Technical Note

Review of Engineering Geology and Rock
Engineering aspects of the construction
of a KBS-3 repository at the Forsmark
site – Initial Review Phase

Author: Erik Eberhardt and Mark Diederichs
Fisher & Strickler Rock Engineering LLC, Radford, VA, USA

Date: August 2012

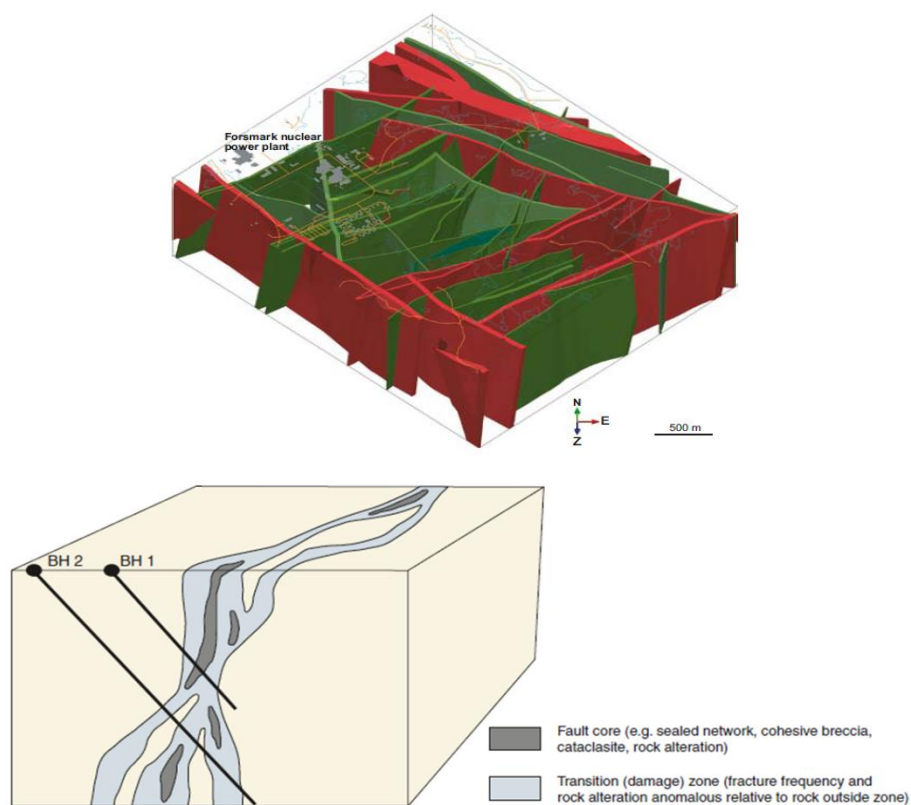
1. Are the surface trace lengths and widths of the major deformation zones representative at depth? The location of the major deformation zones are treated deterministically (R-07-45, §5) but involve projections from surface traces supported by single-borehole interpretations of “possible deformation zones” (R-07-45, §3.3). These assume constant length, width and planarity with depth (see Stage 2.2 Site Descriptive 3-D Model reported in R-07-45, Fig. 5-12, reproduced here in Figure 1, TOP). However, as also indicated in TR-08-05 (p. 141-142), fault zone architecture typically involves branching, undulating structures whose widths can vary significantly with depth (Figure 1, BOTTOM). This is especially relevant to the WNW-NW sets, which are reported as showing clear evidence of a combined ductile and brittle deformational history (TR-08-05, p. 170). Thus, a significant degree of uncertainty to the location and width of the major deformation zones at the repository level can be expected, which may impact the number of Deposition Tunnels/Holes available in relation to the 100 m respect distance criteria. Uncertainty is acknowledged with respect to the characteristics of the deformation zones at depth (TR-08-05, §5.9.2), however it is not evident that this is considered in the qualitative risk analysis in the underground layout design (R-08-116, §8) where increased width and/or change in position may result in altered respect distances that impact to a higher degree on the deposition area.

2. Could there be more problematic sub-horizontal faults at the repository depth than that assessed and accounted for in the Site Descriptive Model? Three gently dipping deformation zones (ZFMA2, ZFMA8 and ZFMB7) are specified as entering the target volume between 400 and 600 m depth, with two of these occurring along or close to the roof of the repository volume (TR-08-05, p. 148). These zones are reported as showing only brittle deformation and having thicknesses that range between 6 and 44 m.

Such features could act as hydraulic conduits, increase the risk of canister shearing, negate large numbers of potential Deposition Holes (based on the EPFC), as well as cause significant construction challenges. Identification of the gently dipping fracture zones is reported to be based on prominent reflectors in the seismic reflection data supported in part by the single-borehole interpretations (TR-08-05, p. 143). This raises the question as to the resolution of the geophysical methods used, as sub-horizontal deformation/fault zones less than the thicknesses reported (i.e. <6 m thick) could equally be problematic. These would also be difficult to detect through cross-correlation with the single-borehole interpretations. Data bias is reported for the north-eastern half of the regional model with respect to the absence of gently dipping zones (reflection seismic data was not available for this area; TR-08-05, p. 175). The size and variation in intensity of the gently dipping fracture zones are acknowledged as significant uncertainties in the Site Descriptive Model (TR-08-05, p. 175), however, the likelihood of encountering a sub-horizontal fracture at the repository level does not appear to be considered in the qualitative risk analysis for the underground layout design (R-08-116, §8). There may be a need to provide provision and contingency for adjusting the vertical elevation of some deposition areas if unfavourable subhorizontal zones are encountered within the horizon or near enough to critically impact deposition hole acceptance (via the EFPC).

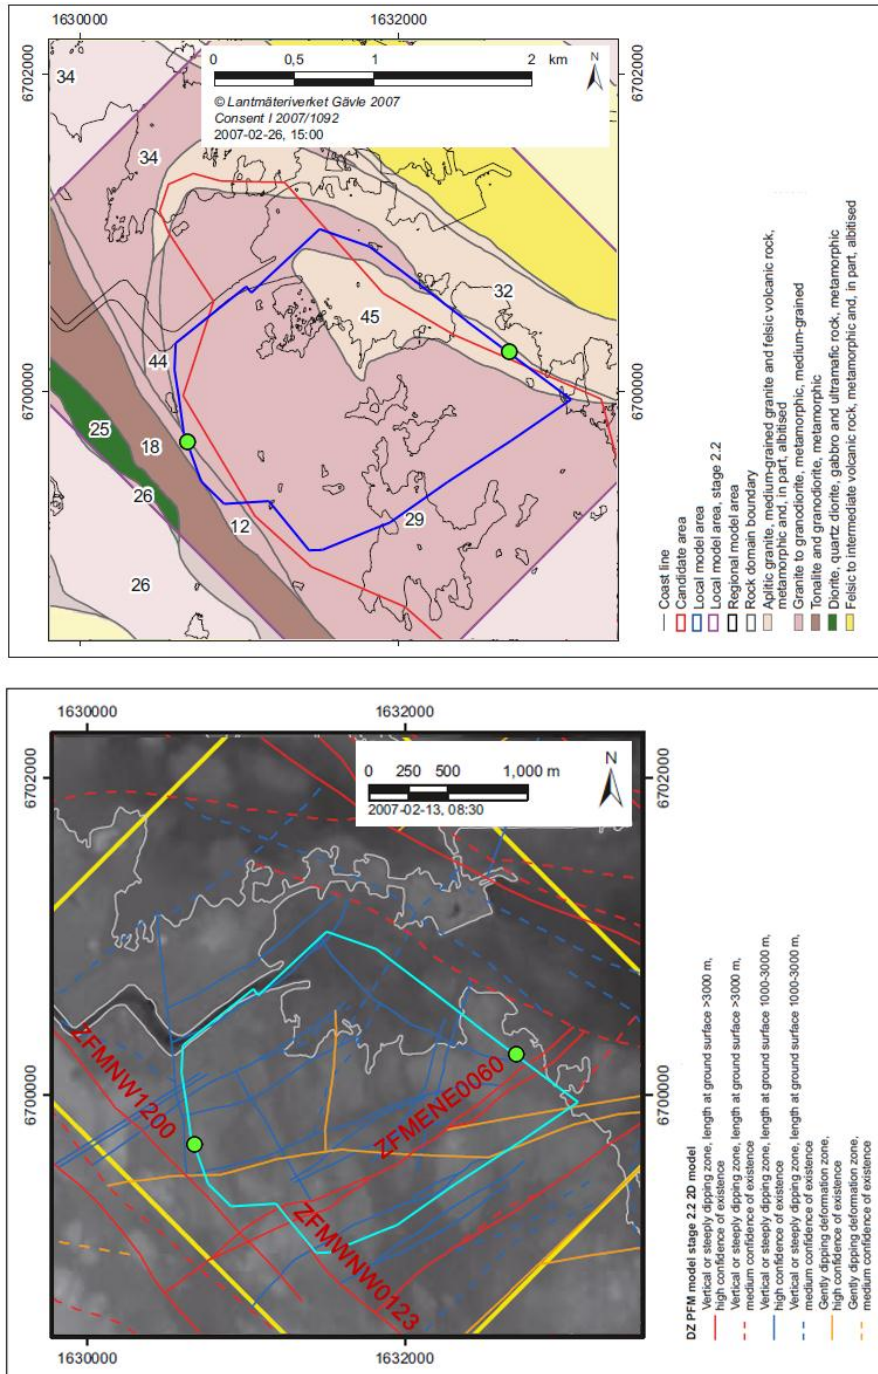
1. RFM012 and RFM044, which are located along the west margin of the target area (Figure 2, TOP), are not discussed in TR-11-01. They are noted briefly in TR-08-05 as being domains that are affected by a high degree of ductile strain (§5.4.4, p. 136). Inspection of the geological data reported in R-07-45 suggests that these domains are associated with major tectonic features that appear to be splays of the Eckarfjärden regional deformation zone. For example, RFM012 is bound by major deformation zones (surface trace lengths >3 km; see ZFMNW1200 and ZFMWNW0123 in Figure 2, BOTTOM). It is likely that these domains will be tectonically disturbed, at least in part, and therefore will be significantly weaker than the rock encountered in RFM029 and that assumed in the various construction reports (see point 2).

2. The layout diagrams for the facility in R-08-116 show that segments of the transport tunnel along its western perimeter will be hosted in these weaker domains (Figure 2, TOP). Other segments are shown as being located along the ZFMWNW0123 major deformation zone (Figure 2, BOTTOM). R-08-116 (p. 37) cites findings in R-08-83 as showing that the rock mass quality of the deformation zones is suitable for locating either the main or transport tunnels. However, relevant sections of R-08-83 (§4.2) do not appear to consider the increased tectonic disturbance to the domains along the western perimeter. Furthermore, whereas a ground type GT4 is specified on p. 61 as applying to the major deformation zones (>3 km), the summary of expected distribution of ground types in the target volume indicates that GT4 will not be encountered (see R-08-83, p. 56). This summary does not appear to agree with the geological data, which suggests that at least some percentage of the transport tunnels will be impacted by poor rock mass conditions related to major deformation zones, specifically ZFMWNW0123 and ZFMENE0060 (Figure 2, BOTTOM).

3. The layout diagrams for the facility in R-08-116 show that the two ventilation shafts are to be located near/within areas of weaker rock and higher water inflows related to major deformation zones (>3 km). The western ventilation shaft appears to be located near a fault that offsets the two tectonically disturbed domains noted above, RFM012 and RFM044 (Figure 2, TOP). The eastern ventilation shaft appears to be located near/within ZFMENE0060 (Figure 1, BOTTOM). While there is operational and sound reasoning for positioning the shafts as proposed, it is not clear that a risk-benefit optimization analysis has been carried out to balance the construction risks associated with shaft sinking and support in these weaker zones versus the need to place the shafts away from the storage areas yet in locations that ensure proper airflow throughout the facility.

- Note that respect distances are specified for the Deposition Tunnels relative to the major deformation zones, and design aspects related to the layout and locating of the central area likewise considers the adverse influence of the deformation zones. The questions raised here are specific to the transport tunnels and ventilation shafts.

C. Recommendations (Category: Clarification/Submission): The assessment of likelihood of encountering sub-horizontal brittle fracture zones at the repository depth does not appear to be considered in the qualitative risk analysis. This appears to be based on the identification of only three gently dipping deformation zones in the Site Descriptive Model. Clarification is requested as to the resolution of the detection methods used (seismic reflection, single-hole interpretations) with respect to the minimum sub-horizontal deformation zone detectable.

Figure 3: Uniaxial compressive test data showing selection of the crack initiation stress value (dashed line) based on the crack volumetric strain reversal. Note subjectivity (+/- 25%) in picking the point of reversal due to the flatness on the minima. From Figures 8-10 in TR-07-01.

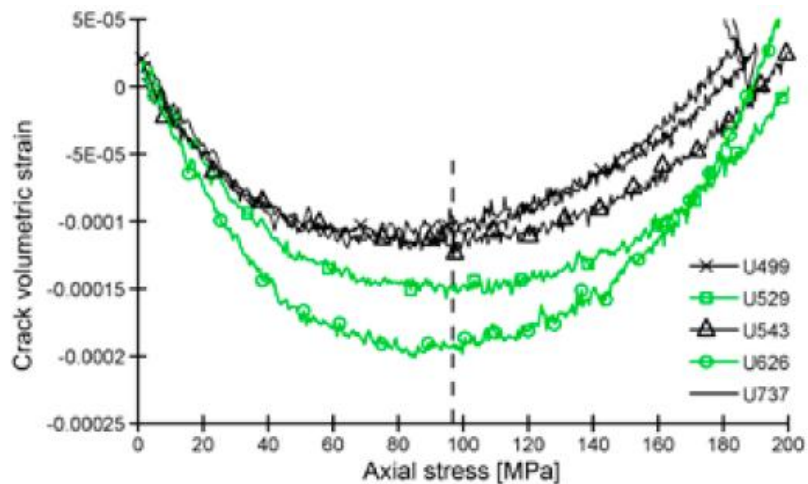
2. The key parameter assessed with respect to spalling potential is the crack initiation stress. Crack initiation values from laboratory testing are considered to be a lower-bound approximation of the *in situ* spalling strength (TR-07-01, p. 103). This was extended to the spalling analysis reported in Appendix C of R-08-116. It should be noted though, that the laboratory procedure used to determine the crack initiation values, as described in TR-07-01 (§8.3), introduces a significant degree of subjectivity and error. The technique is based on plotting strain gauge data from uniaxial compression tests and picking the point of crack volumetric strain reversal, which is calculated from (and therefore partly dependent on) Young's modulus and Poisson's ratio values. Apart from the differences in values that may arise from uncertainties in the elastic constants, selecting the point of reversal has an approximate accuracy +/- 25% given the flatness of the minima of the curve and resolution of the stress-strain measurements (Figure 3). As acknowledged in TR-07-01 (p. 103), determination of the crack initiation stress is not straightforward. Although the uncertainty in the stress field is the dominant uncertainty with respect to spalling potential, should consideration also be given to the impacts of uncertainty in the spalling strengths on design?

C. Recommendations (Category: Clarification/Submission): Is the exclusion of Deposition Holes in low thermal conductivity rock included in the Deposition Hole acceptance/rejection criteria? Do the analyses of loss of Deposition Hole positions account for the likelihood of amphibolite lenses occurring more frequently than indicated?

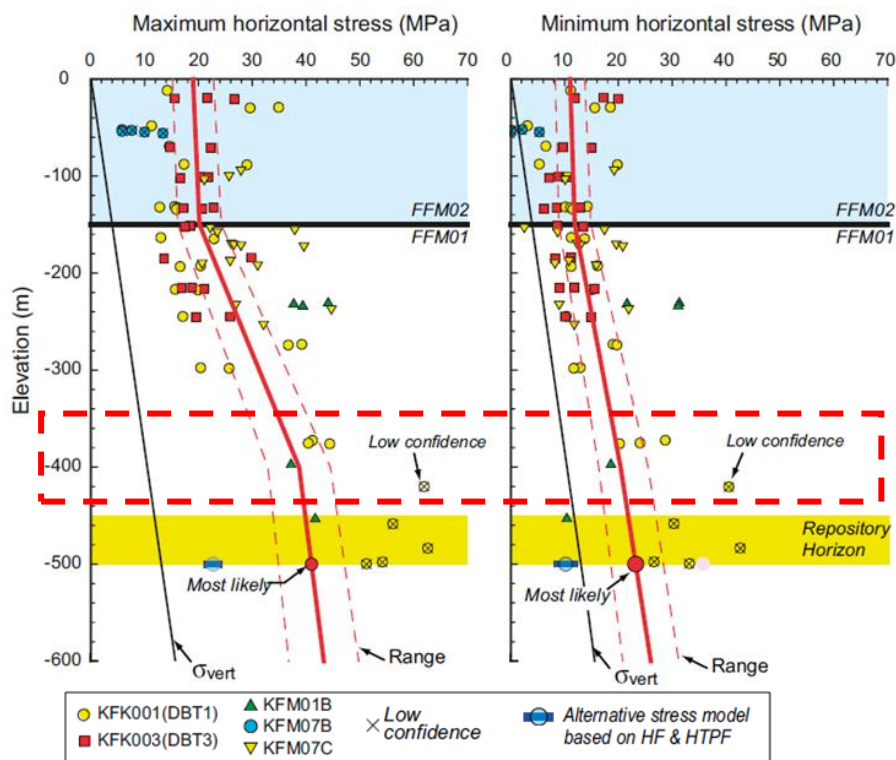
Removal of this borehole from the dataset results in a significant change in the interpretation (see Figure 4). Rejection of this data needs to be more thoroughly justified and seems to be based on the overestimate of vertical stress. While this does justify possible rejection of the data, it is possible that this overestimation of vertical stress (higher than overburden pressure) is due to anisotropic damage in the vertical core resulting in a higher vertical stress estimate (i.e., greater relaxation strains in the overcore in this direction). Such damage would not have the same impact on the horizontal stress estimates. Similarly, there are numerous uncertainties in the alternative approaches (including estimate of true borehole strength for back analysis of breakouts) that it is unclear as to the justification for exclusion of some of the overcoring data. As such, the *in situ* stress values are based on a number of unverified (although possibly valid) assumptions, under which the stated “likely” maximum stress (σ_H) at the target depth could be underestimated by up to 25 to 35% (i.e., resulting in “likely” horizontal stresses as high as 50-55 MPa instead of the stated 41 MPa). While this higher range is reported, it is taken into account as an unlikely scenario. Note that the implication of higher stresses or more extreme stress

ratios is the inclusion of spalling and/or structural shear. These mechanics do not currently figure in the design considerations.

2. What is the mechanism by which the trend of the maximum horizontal stress decreases in gradient at 400 m depth but the trend of the minimum horizontal stress remains linear (see red dashed box in Figure 4). The change in trend at 150 m makes sense as a different fracture domain is being entered (and is reflected in both the maximum and minimum horizontal stress). However, there is very limited justification for the decrease in trend at 400 m in the reports provided. The conclusion is discussed in R-07-26 (§7.2.4) although the reasoning is potentially insufficient to justify such a significant diversion from the measured trends.

Figure 5: Map of the Forsmark site showing the locations of the cored boreholes, from Figure 2-10 in R-07-26. Red circle added to highlight locations of DBT1 and DBT3 (stress measurement boreholes) outside the Target Area.

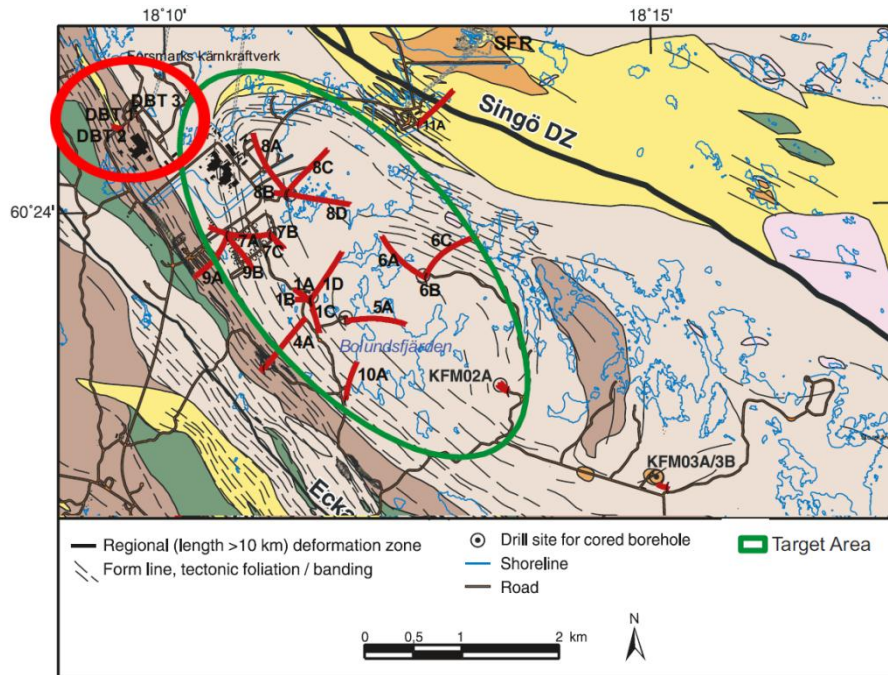
3. It is unclear whether the stress regime measured in boreholes KFK001/DBT1 and KFK003/DBT3 are applicable to the repository volume. The Site Description report (TR-08-05) reports these boreholes as being drilled in FFM04 (p. 214), which is situated outside the target volume and involves different rock and fracture domains (see Figure 5). Given the complex regional structural geology, and the influence it can have on the stress field (as seen in the change in trend at 150 m in Figure 4), the applicability of these measurements to the repository volume is questionable. As shown in Figure 4, these data points represent the majority of the data on which the *in situ* stress interpretation is based.

C. Recommendations (Category: Clarification/Submission): Are the stresses measured in boreholes KFK001/DBT1 and KFK003/DBT3 located outside the target volume and in FFM04 applicable to the repository volume? How would the stress interpretation change if these data were excluded?

Figure 6: EDZ experiment at Äspö, showing block extraction from tunnel wall to analyze for continuous EDZ. Superimposed are the stated stress magnitudes and orientations for the experiment location. From Figure 4-6 and Table 2-1 in R-09-39.

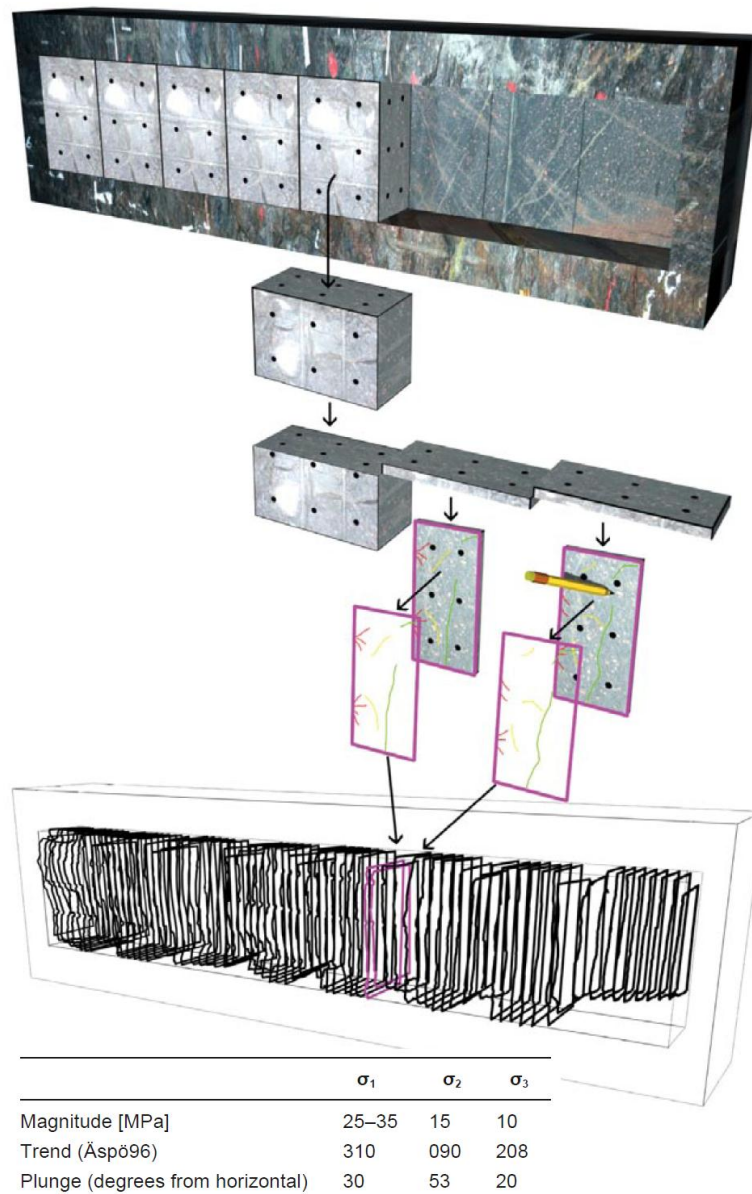
1. The conclusion that the EDZ if it develops is not continuous is based on the conclusions from a large *in situ* experiment conducted at Äspö, as reported in R-09-39. This experiment was conducted under a stated *in situ* stress field with $\sigma_1 = 25\text{-}35 \text{ MPa}$, oriented at 30 degrees from horizontal. A tunnel was excavated using drill and blast techniques, from which samples were cut from the tunnel wall (Figure 6). First, it should be noted here that these test conditions are based on lower stress conditions than those expected at Forsmark. More importantly though, the samples were cut from the tunnel

walls and not the tunnel roof. Such samples will capture the blast-induced damage, which would be expected to develop more or less uniformly around the entire tunnel perimeter. However, any fracture damage resulting from the redistribution of stresses (i.e. stress-induced damage) would be expected to concentrate in the tunnel roof and floor in response to the stress field orientation. As such, any conclusions derived from this study can only be extended to the connectivity of blast induced damage (i.e., Construction Damage Zone, CDZ) and not the stress-induced EDZ. Given that blast fractures would be expected to be radial relative to the tunnel boundary, it is not surprising that subsequent testing of the rock showed that the damage was not connected along the length of the tunnel.

Figure 7: Irregular tunnel boundaries with look-outs created by drill and blast advance (TR-10-18, p. 24). Included is an example of a suggested linear overbreak criterion to compliment those based on total volume and section area overbreak limits.

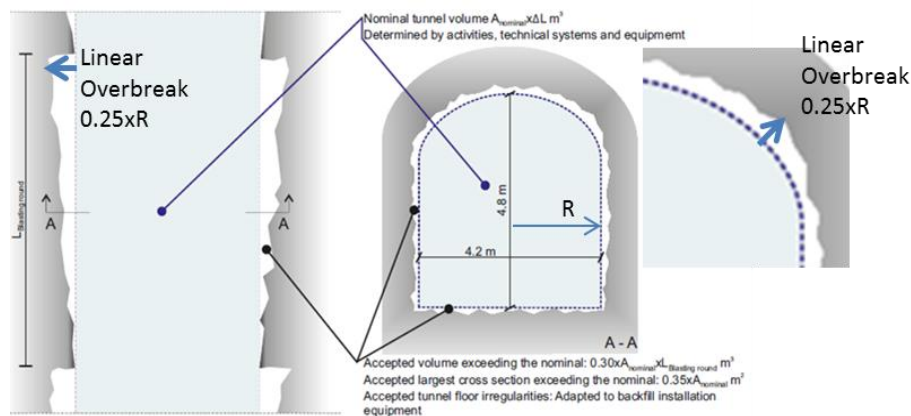
Look-outs created through drill and blast advance may inhibit proper backfill expansion (Figure 7). Similar compatibility issues between the backfill/tunnel interface may also arise where blocky rock mass conditions are encountered (Figure 8). An overbreak limit of 30-35% as stated in the *Design Premise* for Deposition Tunnels seems excessive and incompatible with the requirement to minimize construction damage. If the specified total volume and section area overbreak limits are maintained, then the reviewers recommend adding a third linear limit to ensure local exceedance is minimized. For example: *Acceptable largest linear overbreak (measured normal to design profile) should not exceed the nominal $0.25 \times \text{Radius}$ for a circular profile or $0.13 \times \text{Span}$ for a square profile (see Figure 7).*

E. Recommendations (Category: Clarification/Submission): Is the 30-35% overbreak limit expressed in the *Design Premises* for Deposition Tunnels excessive or incompatible with the requirement to minimize construction damage? Can this be reduced to improve overall quality control? If the specified total volume and section area overbreak limits are maintained, should a third linear limit be added to ensure local exceedance is minimized? For example: “Acceptable largest linear overbreak (measured normal to design profile) should not exceed the nominal $0.25 \times \text{Radius}$ for a circular profile or $0.13 \times \text{Span}$ for a square profile”.
